# Capital Area Transportation Authority

## AMENDMENT NO. 1 TO SOLICITATION SIGN AND SHELTER VEHICLE

1. AMENDMENT NO: 1	2. SOLICITATION NO: RFP 2019-102	3. SOLICITATION NAME: Sign and Shelter Vehicle	4. AMENDMENT DATE: July 9, 2019
-----------------------	-------------------------------------	---	------------------------------------

Capital Area Transportation Authority Request for Proposal 2019-102  
Sign and Shelter Vehicle  
CATA Response to Vendor Questions or Approved Equals

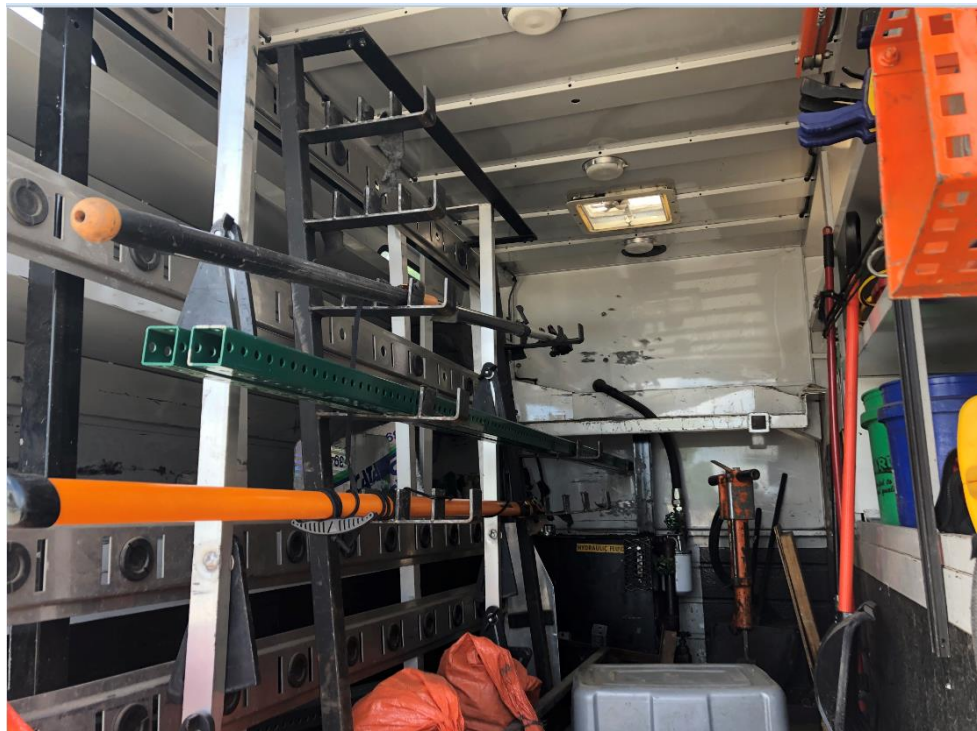
**2. Please provide pictures of existing Pole Rack so we can price it.**

Please see picture below of CATA's existing pole rack:
